I, Michael Hays, am submitting this statement to provide the information specified in 11-Y DCMR § 302.12. The information requested in 11-Y DCMR § 302.12(a)-(d) is set forth on Form 125. The additional information is set forth below.

I. INTRODUCTION

The Zoning Administrator's approval of the subdivision of Lot 108 ("Subdivision") must be reversed and vacated. That Subdivision approval, for which the Zoning Administrator offered no written analysis, violates numerous provisions of the Zoning Regulations, including in particular the violation of the required 1 to 3 ratio of the depth of the rear yard to building height requirement set forth in 11-F DCMR § 605.1.

Figure 9

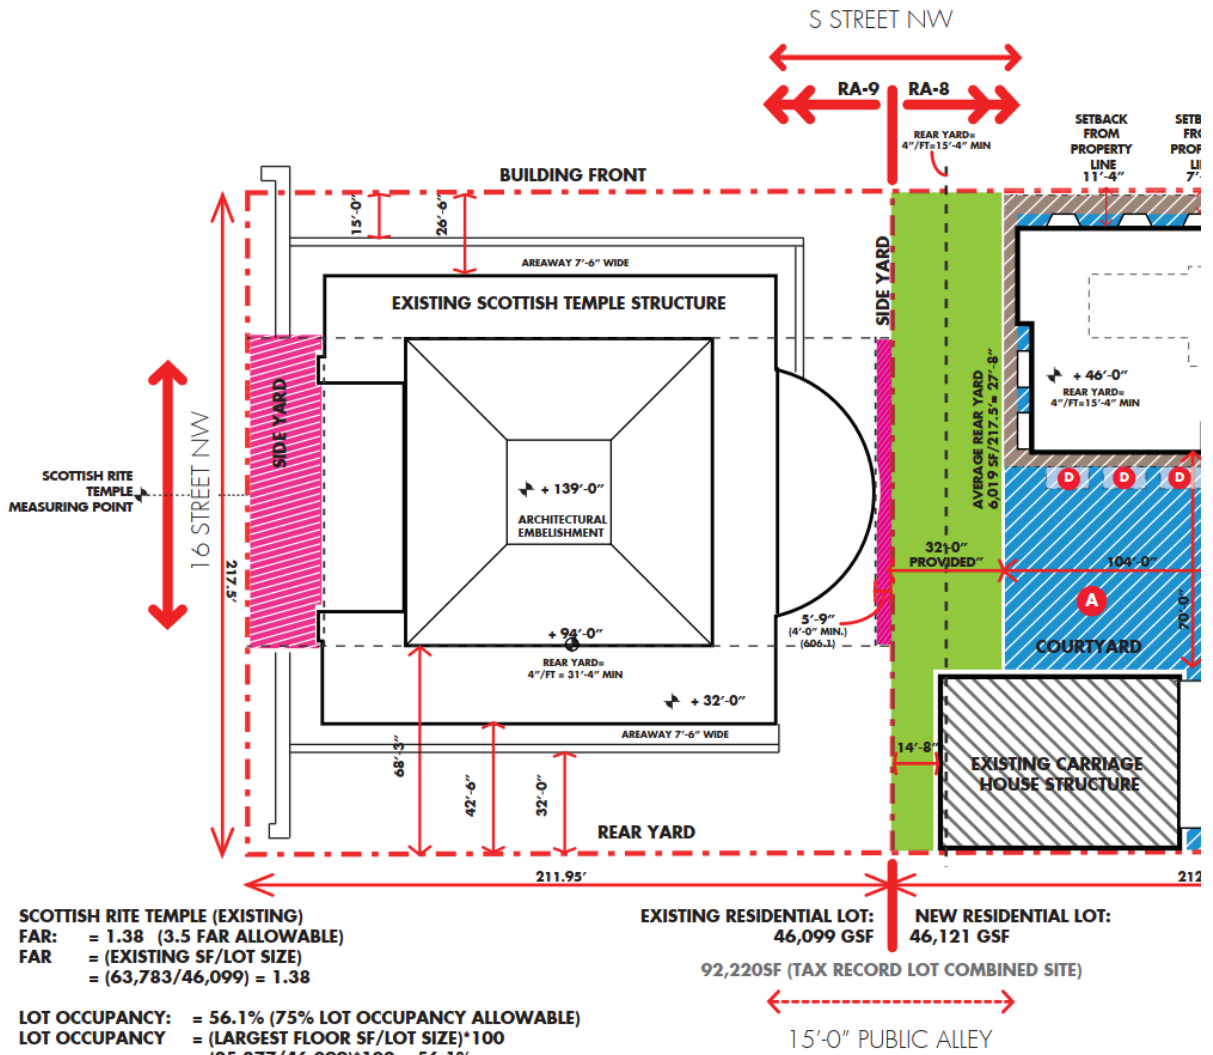
The Applicant’s intent is to build a 5-story apartment building (4 stories above grade with an additional level of residential penthouse apartments on the building’s roof), plus two levels of subterranean residential cellar apartments, and a two-story underground parking garage – all on the green grassy park-like area shown in Figures 7 and 8. The Subdivision line would run less than 6 feet from the majestic Masonic Temple building shown above. Lot 108 is currently split zoned as shown in Figure 9 below, which was prepared by the Applicant’s architects (**Exhibit 3** hereto at A-9).¹ Lot 110 would be in a RA-9 zone and Lot 111 would be in a RA-8 zone as shown in Figure 9 below:

Figure 10

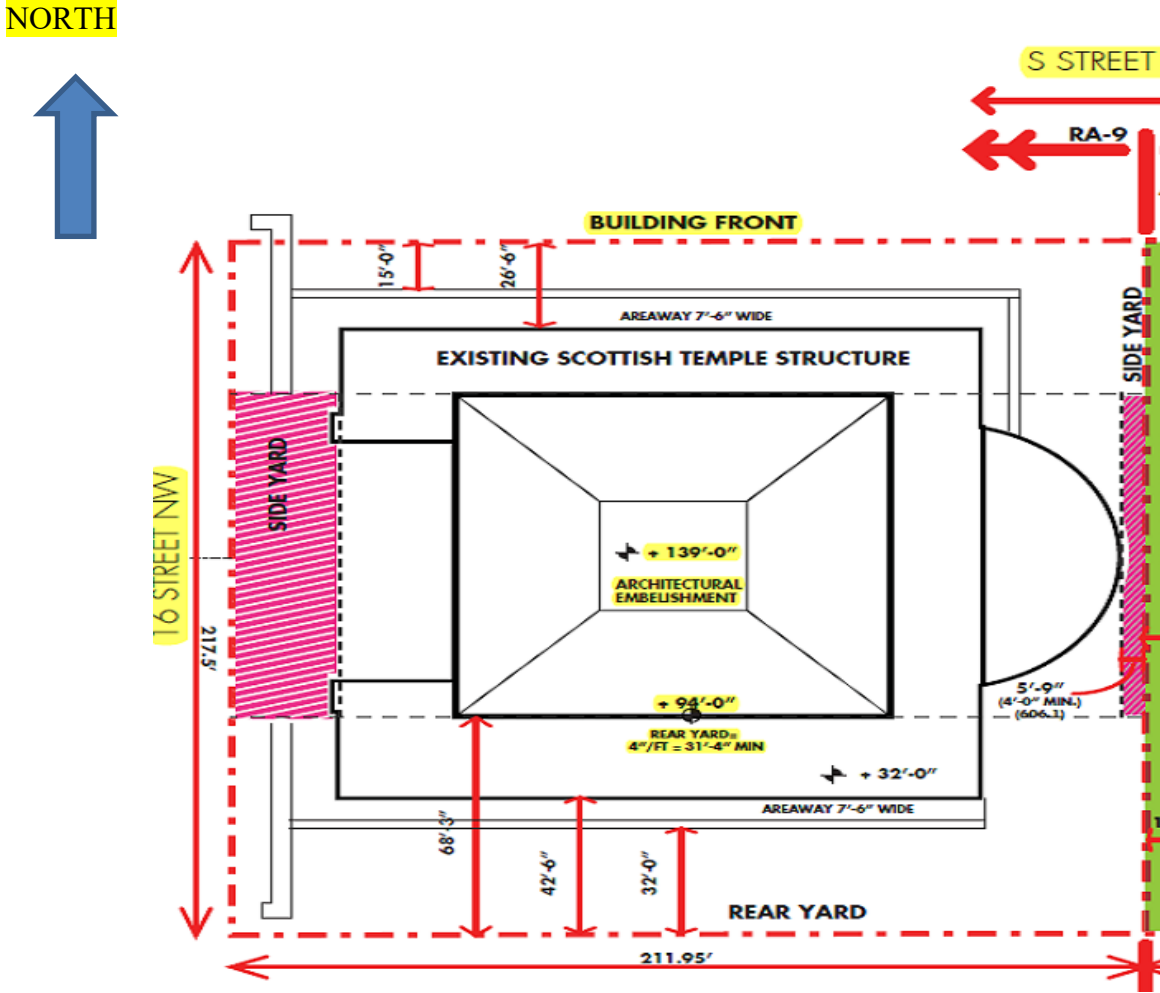
Figure 10 below sets forth these proposed Redesignations. That diagram is from the Application Package that the Applicant submitted to HPRB (**Exhibit 3** hereto at A-9, available at https://drive.google.com/file/d/1i9xXfj_g4IPLbwrPwJ2oiBmvkZtpC4qc/view?usp=sharing):

As set forth below, the Temple Redesignations create a violation of the minimum rear yard requirements set forth in 11-F DCMR § 605.1 because the ratio of the height of the Temple roof to width of the rear yard exceeds the permissible ratio. Therefore, the Zoning Administrator’s approval of the Subdivision must be reversed and vacated.

However, as revealed in Figure 10, there is an “areaway” 7’6” wide at both the redesignated front and rear of the Temple. Pursuant to the Zoning Regulations:

Using the information set forth by the Applicant in Figure 10, the rear yard is 32'-0". Thus, the proposed rear yard is non-conforming, making the proposed Western Lot of the Subdivision non-conforming.

Based on its Figure 10 (shown above), the Applicant apparently contends that the 332 ton roof of the Temple, which is in the shape of a pyramid, does not constitute a "roof" under the applicable Zoning Regulations, but is rather an "embellishment" and thus should not contribute to the Temple's building height. Under this bizarre approach, the Applicant is apparently contending that the height of the Temple is only 94', which means the rear yard must be only 31'4" wide, narrowly coming within the 32' from the areaway to the property line.

Figure 12

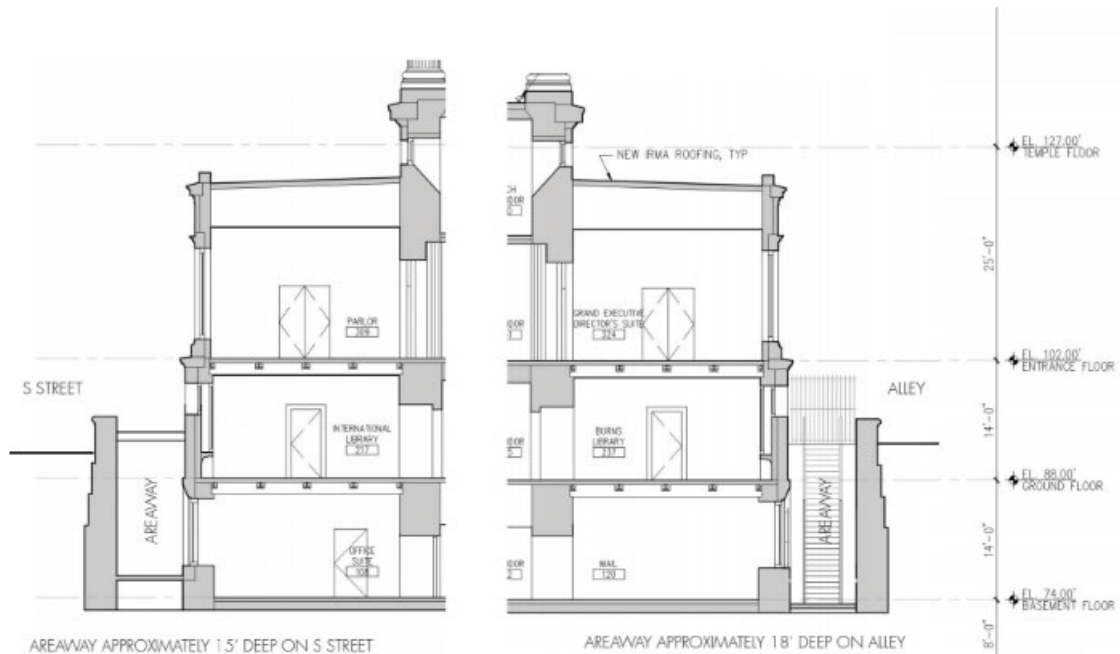
Per Figure 12 below prepared by the developer (**Exhibit 3** hereto at A-84), the areaway at the redesignated “front” of the Temple on S Street is 15 feet deep:

Therefore, that 15 feet must be added to the height of the building (140') for a total height of 155'. Multiplying that number by 1/3 reveals that that minimum depth of the rear yard must be at least 51' 8". However, as shown in Figure 10, the proposed redesignated rear yard is only 32'.

The 32' is the depth of the redesignated "rear yard" measured from the edge of the areaway to the south property line. The "rear yard" cannot include the areaway, per the definitions of "Yard" and "Rear Yard". The Zoning Regulations define "yard" as:

Figure 15

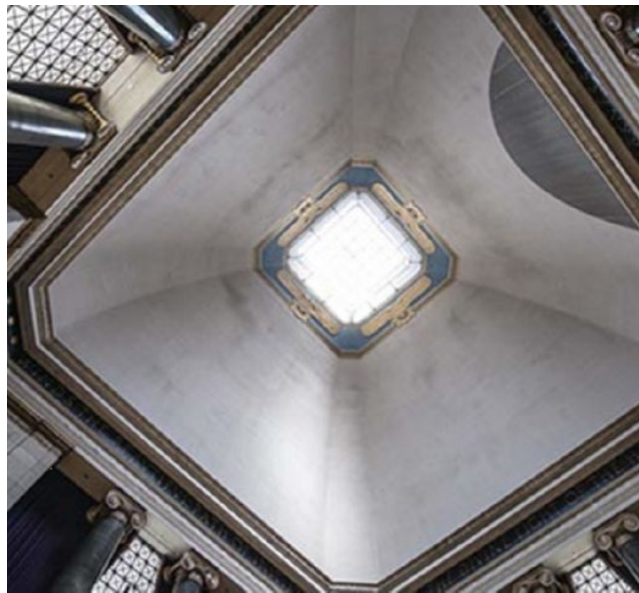
Below is a picture of the pyramid roof from the interior of the Temple. As you can see, the pyramid forms the roof over the interior. It is important to the Masonic tradition that it does so, and it was designed and built to be a pyramidal roof whose form shows on the inside and on the outside of the building.

The 332 ton pyramidal roof is as essential to the Scottish Rite Temple as the dome of the Jefferson Memorial (also designed by Pope) is essential to the memorial. The Jefferson Memorial’s domed roof impacts both the interior and the exterior of the Memorial in ways remarkably similar to the Scottish Rite Temple’s pyramidal roof. The pyramidal roof is not an
